Post Implementation Review

Gisborne CBD Cycleway

Stage one: Sponge Bay to Wainui

May 2017

Figure 9: Number of recorded crashes within the greater project area

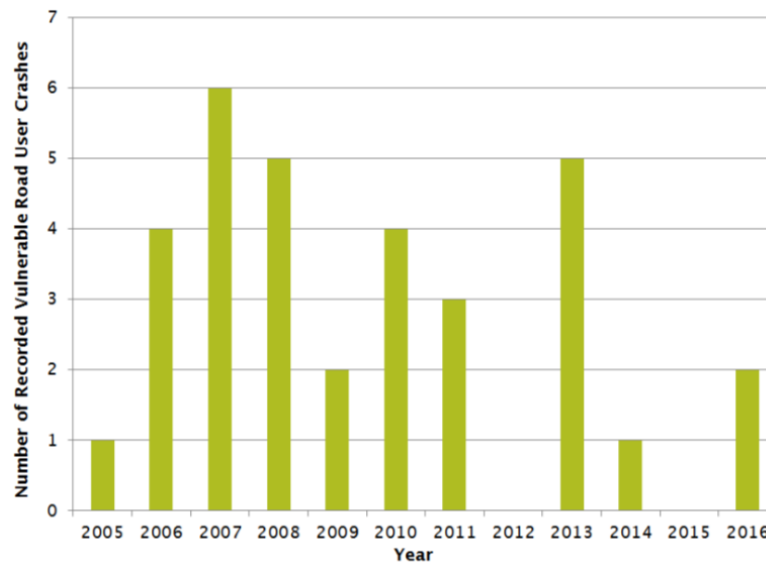
It is reasonable to expect that the shared path has increased the presence of vulnerable road users at adjacent locations on the wider road network. A review of crash records from the wider road network, as depicted in Figure 9, does not provide any evidence to suggest a notable change in either vulnerable road user crash frequency or severity trends.
